JUMPER CARTER SEASE/ARCHITECTS, P.A.
412 MEETING STREET, WEST COLUMBIA, SOUTH CAROLINA 29169
(803) 791-1020 (803) 791-1022 FAX

UNIVERSITY OF SOUTH CAROLINA CAPSTONE CAMPUS ROOM UPGRADES

PROJECT NO: 11103

ADDENDUM 02

5
1-7
CEILING DETAIL
SCALE: 1 1/2" = 1'-0"

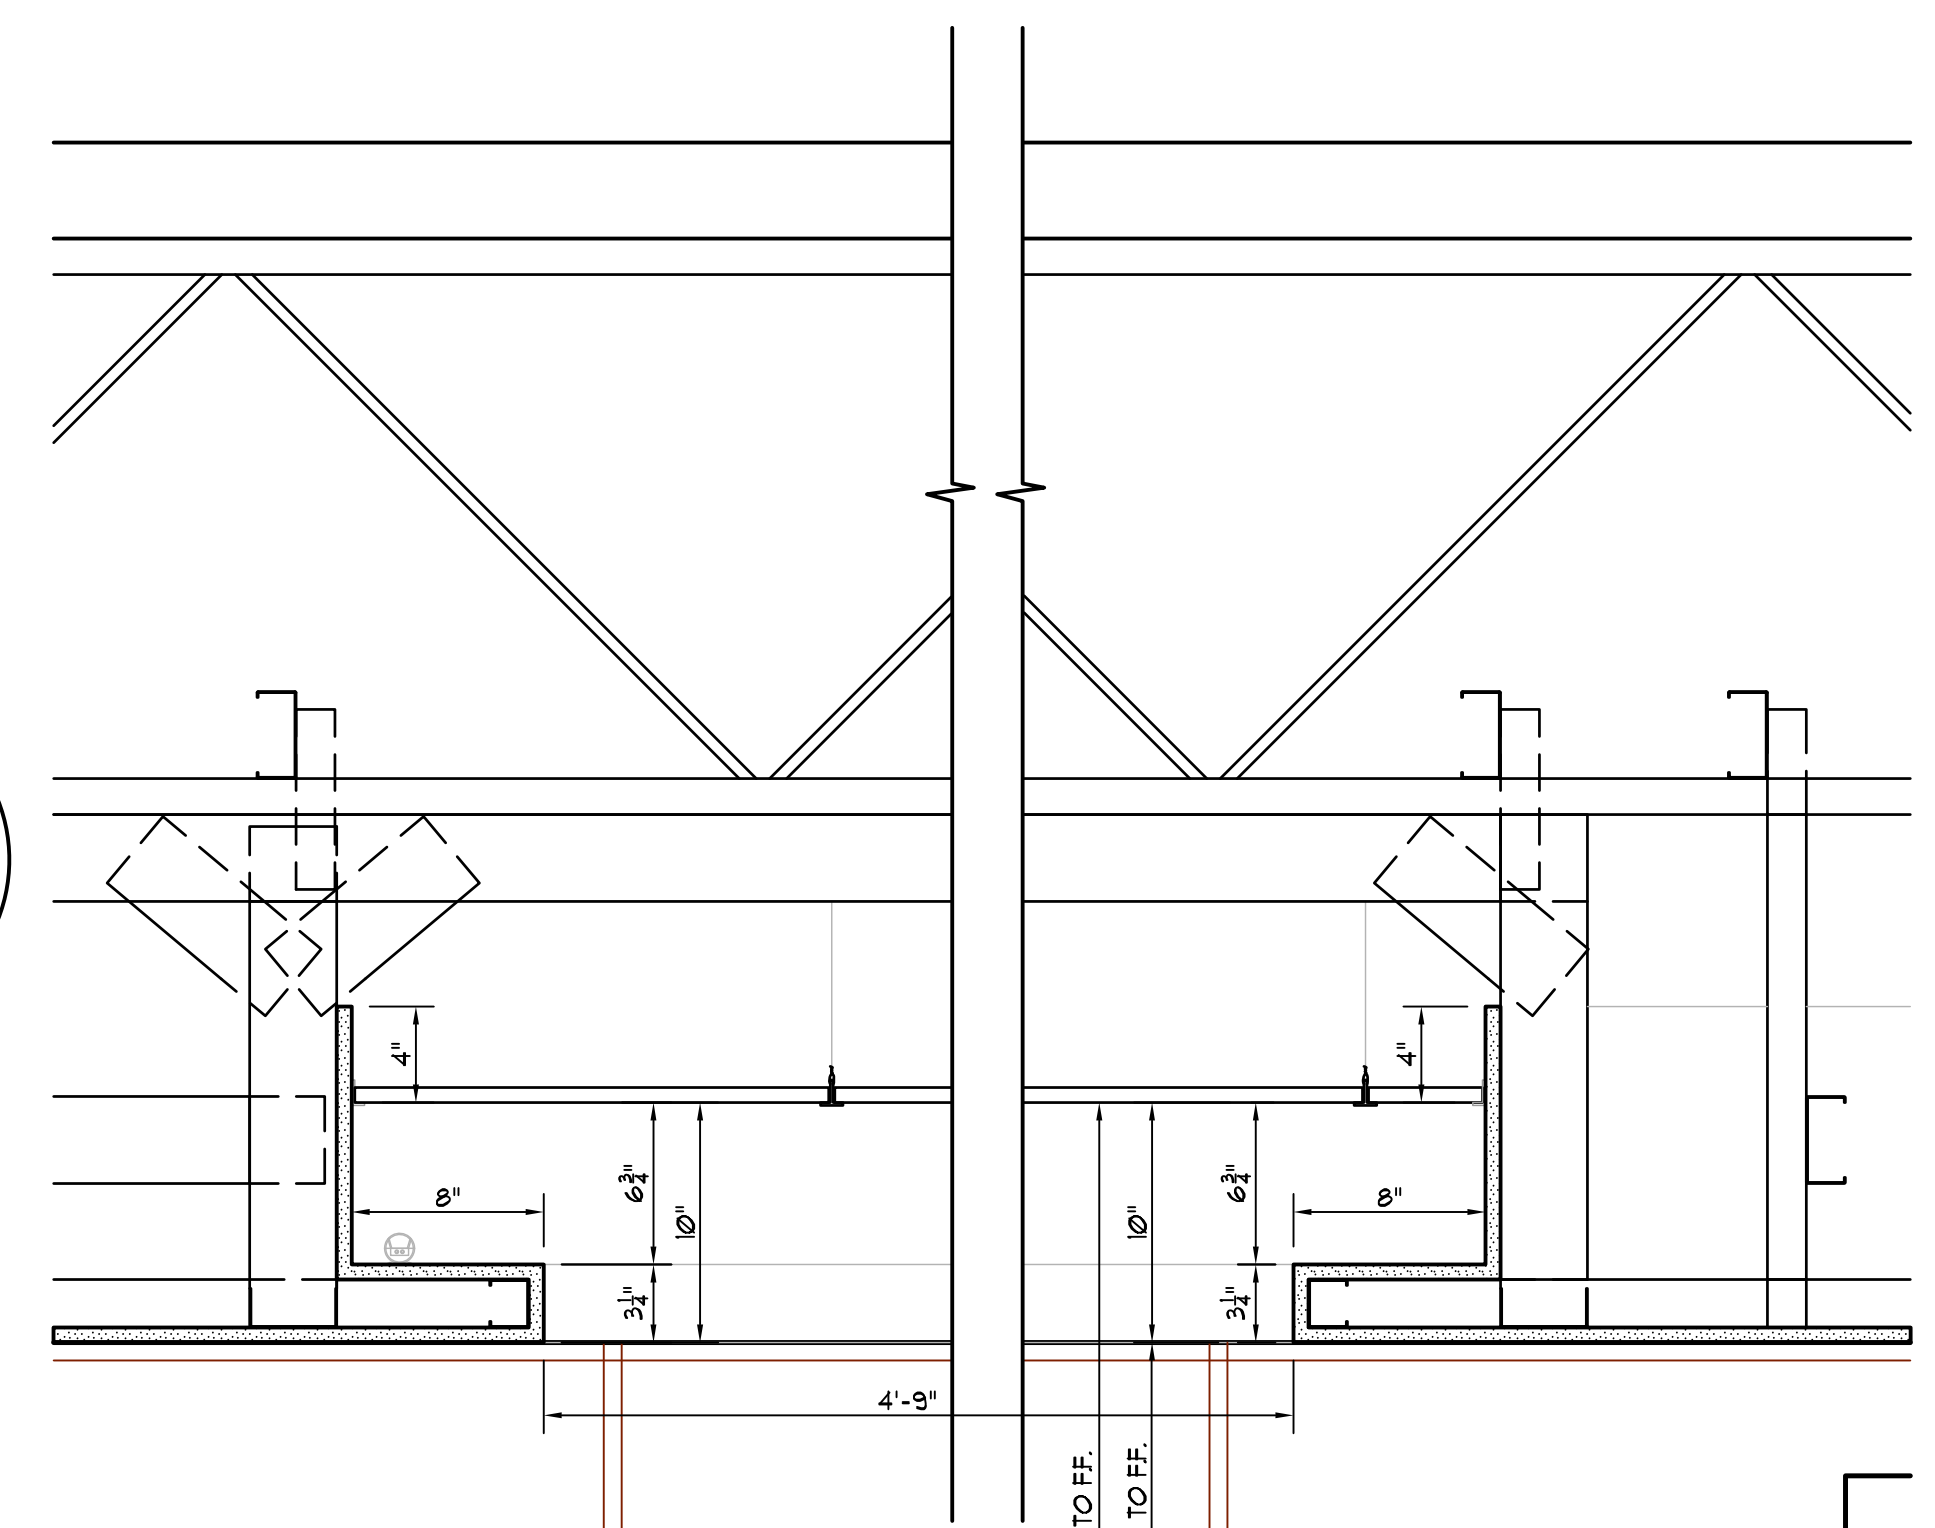
- 1. Drawing I-7 CEILING DETAILS: OMIT** Drawing I-7 and **REPLACE** it with NEW DRAWING I-7.
- 2. Drawing I-5 DOOR & FINISH SCHEDULES / COLOR SCHEDULE / DOOR & WINDOW TYPES & DETAILS / PANEL DETAILS; CHANGE** Wood Veneer Panel Reveal Details as shown.
